Takes of Marine Mammals Incidental to Specified Activities; Taking Marine Mammals Incidental to an Exploration Drilling Program in the Chukchi Sea, Alaska

ACTION: Notice; issuance of an incidental harassment authorization.

SUMMARY: In accordance with the Marine Mammal Protection Act (MMPA) regulations, notification is hereby given that NMFS has issued an Incidental Harassment Authorization (IHA) to Shell Gulf of Mexico Inc. (Shell) to take marine mammals, by harassment, incidental to offshore exploration drilling on Outer Continental Shelf (OCS) leases in the Chukchi Sea, Alaska.

Figure 1. Source levels in 1/3-octave bands for the drillship Discoverer and ice management surrogate vessel (the ice handler Maersk Rover).

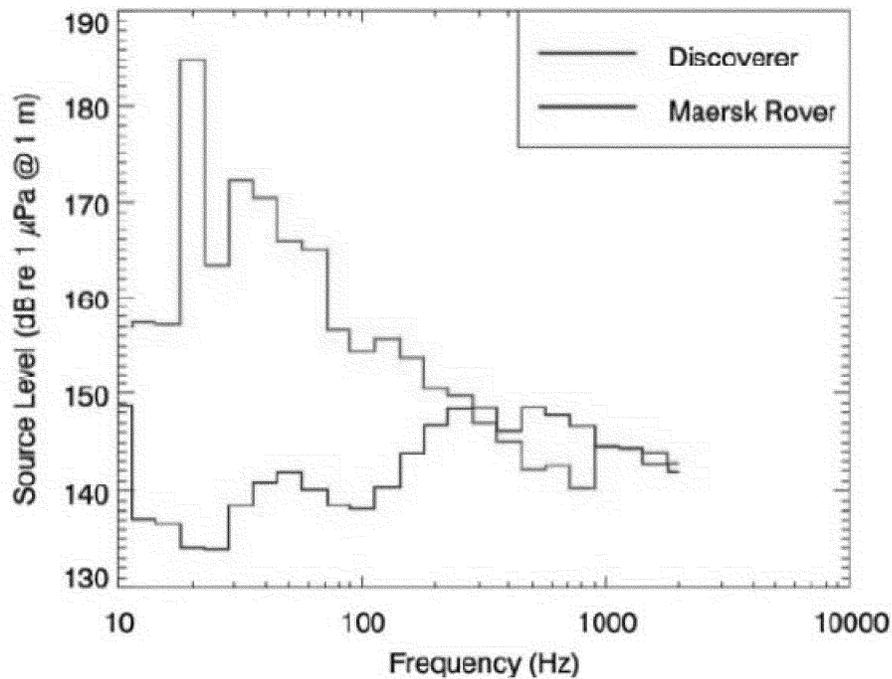
Comment 26: The MMC states that it is not clear which specific source level was used to model the size of the corrected 120-dB re 1 μ Pa harassment zone for the *Discoverer*, as the reported source levels for the *Discoverer* ranged from 177–185 re 1 μ Pa at 1 m. It also is not clear how the source level measurements taken in the South China Sea were incorporated in the model to estimate the 120-dB re 1 μ Pa harassment zone in the Chukchi Sea.

Comment 27: Dr. Bain notes that sound propagation efficiency depends on conditions and that the modeling used by Shell does not capture the most efficient mode of propagation. He also states that there is great uncertainty with source levels based on single measurement locations, as was done for the *Discoverer*.

Response: The modeling analysis considered 1/3-octave band levels to account for frequency-dependent propagation effects that cannot

adequately be characterized with broadband analysis. The 1/3-octave band source levels were obtained from dedicated measurements of the *Frontier Discover* (now *Noble Discoverer*) during drilling activities in the South China Sea. A plot showing these levels is provided in the response to *Comment 27*, and the corresponding broadband levels could be computed by summing those if required. The modeling approach applied by JASCO Applied Science was the MONM parabolic equation acoustic propagation model in each 1/3-octave band from 10 Hz to 2 kHz. The resulting received band levels were summed to compute the broadband received levels at many depths, distances and directions from the planned drillship location. Representative sound level threshold radii were determined by calculating the 95th percentile distance, over all azimuths, at which the maximum threshold over all depths was received. This approach considers that animals may sample multiple depths as they pass by the drilling operation.

Response: The concern raised here about variability of profiles is addressed in the response to *Comment 29*. With regard to the question on which source levels were used for modeling, this study considered 1/3-octave band source levels from the *Discoverer* drillship obtained during dedicated measurements performed in 2009 in the South China Sea (Austin and Warner, 2010). The specific levels are representative of the drilling operation since that activity will occur for the majority of time. The source levels used

Figure 2. Temperature, salinity, and sound speed profiles at the Burger prospect obtained from the GDEM database for October.

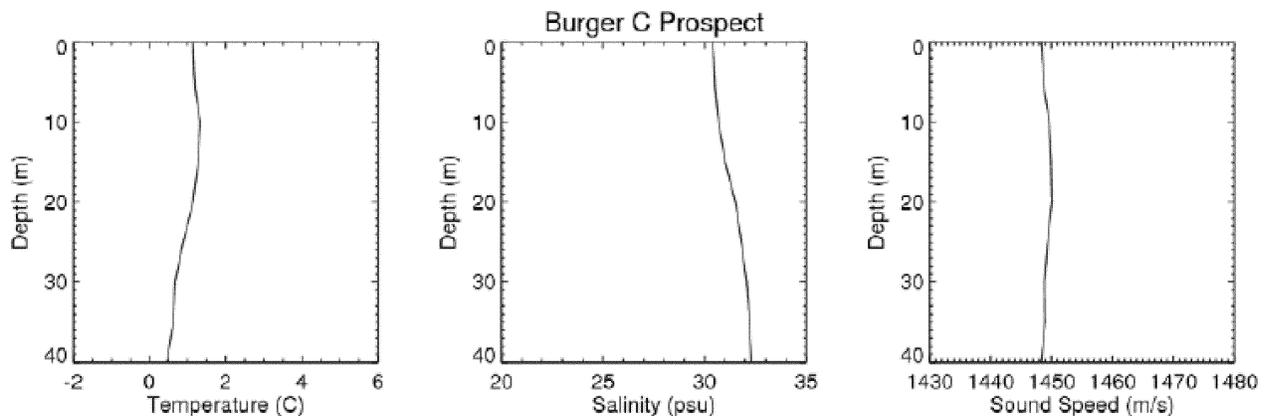
Comment 29: Dr. Bain states that the correction factor of 1.5 applied to the distance to the 120 dB contour is inadequate to conservatively account for the variability.

Response: The concern raised here is that the sound speed profile used for acoustic modeling of drill rig noise may not account for changes to the salinity and temperature profile that could influence and create variability in sound propagation, and the resulting variability might lead to conditions in which model estimates would not be conservative. The location-specific sound speed profiles considered for this modeling study were obtained from the GDEM database for conditions in July and October. A modeling study (Johnston *et al.*, 2009) investigated the difference in sound propagation for both months and showed longer-range sound propagation using the October profile. To be precautionary and to avoid underestimating the propagation, the modeling at the Burger prospect that was used for marine mammal effects assessment was conducted using the October profile (see Figure 2). Therefore, a correction factor of 1.5 is appropriate in this circumstance.

Figure 3. Band levels for the Kulluk during drilling.

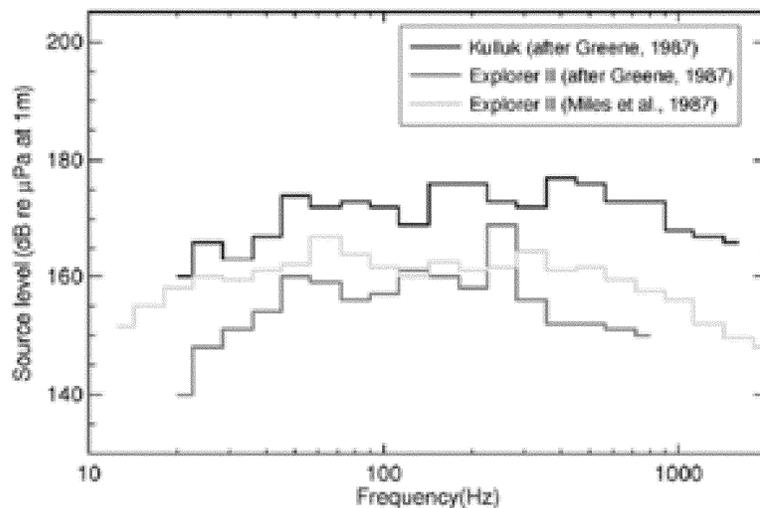
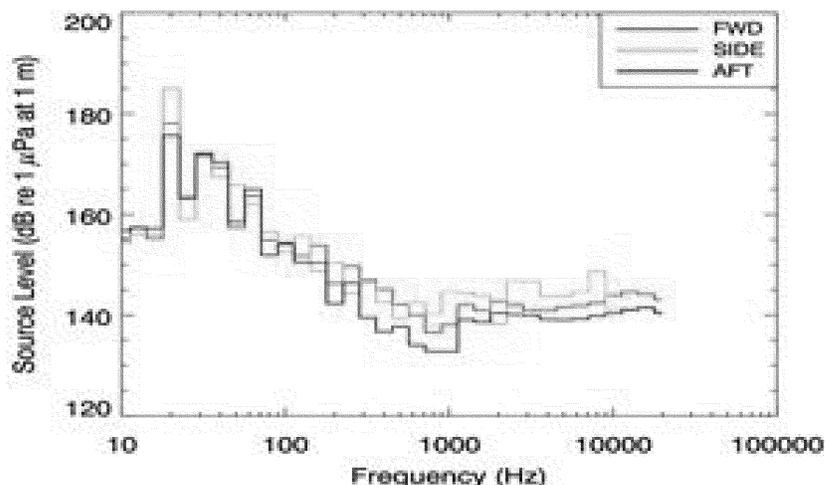
Comment 37: The NSB and AWL note that the modeled 120-dB isopleths for the *Discoverer* are different in the Beaufort and Chukchi Seas (with the isopleth being slightly smaller in the Chukchi Sea). Additionally, they question if the 120-dB isopleth for the *Discoverer* is correct given its nearly identical source level to the *Kulluk* drill rig (proposed for use in the Beaufort Sea), for which sound propagates out to the 120-dB isopleth at a much farther distance. If the modeled propagation is incorrect for the *Discoverer*, then this would bias the take estimates low.

Response: The primary reason for the difference in the distance of the 120-dB isopleths for the *Discoverer* in the Beaufort Sea vs. the Chukchi Sea is due to differences in the geoacoustic parameters for the two seas that were input to the model. Water depth, seabed density, and seabed sound speed are generally the most important parameters that influence sound propagation.

Differences in sound propagation from the two rigs are real and are caused by differences in the design of the two vessels. While the broadband source levels for the *Discoverer* and *Kulluk* may be similar, their spectral properties differ considerably. Acoustic modeling considers the source levels in 1/3-octave frequency bands. Figures 3 and 4 show the band levels for both drillships during drilling. Of key importance are the significantly lower levels of the *Discoverer* in the 50 to 500 Hz bands that propagate well in the relatively shallow waters of these drilling operations. While the *Discoverer* apparently has higher band levels below 50 Hz, this energy is more rapidly attenuated than higher frequency sound energy. This characteristic of sound propagation in shallow waters leads to predominantly mid-frequency sounds (50–500 Hz) dominating the acoustic field at distance from the drillships. A further consideration is that the *Kulluk* source levels are known to include contributions from support vessels, and much of the mid-high frequency band
